SERVICE BULLETIN SB-37

SUBJECT: Aft C121-25 Push-Pull Tube Contact with Mast Fairing Rib

ROTORCRAFT AFFECTED: R44 Helicopters S/N 0653, 0655, 0661, 0664, 0665, 0667 thru 0678, 0680 thru 0683, 0686 thru 0695, 0698, and 0709.

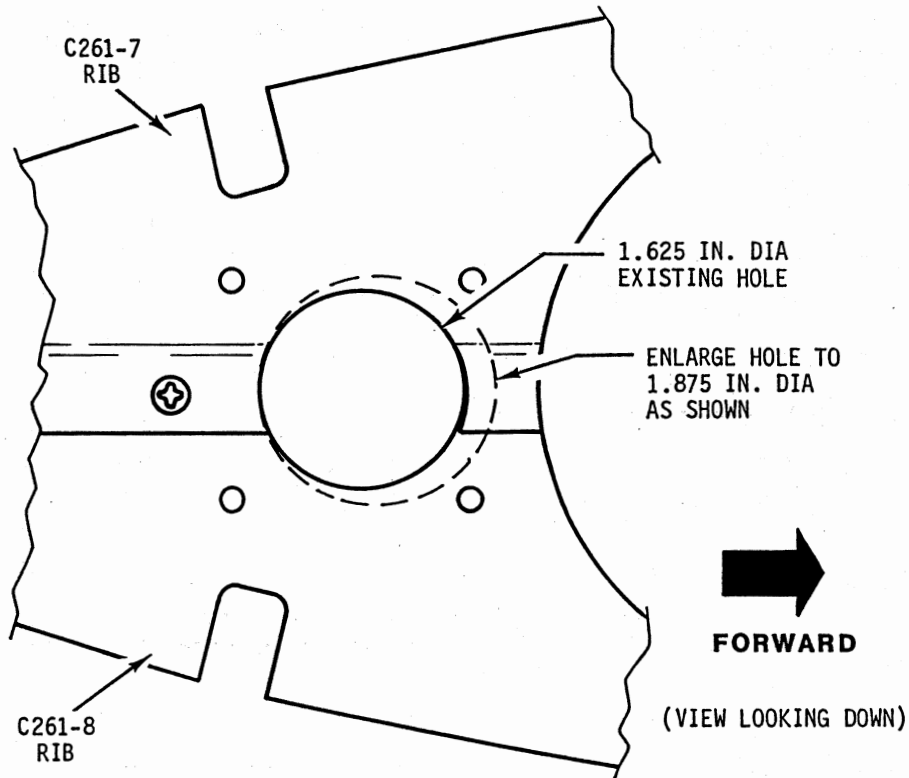
BACKGROUND: RHC has received reports of the aft C121-25 push-pull tube rubbing the mast fairing middle rib. Enlarging the rib hole will provide necessary clearance.

5. Securely assemble both halves of middle rib without aft grommet.
6. With a 1.875 inch diameter circular template (a socket with an outside diameter of 1.875 inch will work), layout and mark the boundary of the hole enlargement as shown in figure on page 2.

7. Using a rotary file, nibbler, or similar tool, enlarge hole from 1.625 to 1.875 inch diameter along boundary marked in preceding step.
8. Disassemble rib. Deburr and polish enlarged hole edge and prime with zinc-chromate or epoxy primer.

10. Install NAS557-28A grommet in enlarged hole.
11. Connect forward push-pull tubes to hydraulic servos. Torque bolts and palnuts per R44 MM Section 1.320 and torque stripe.
12. Install mast fairing skin.
13. Make appropriate maintenance record entries.
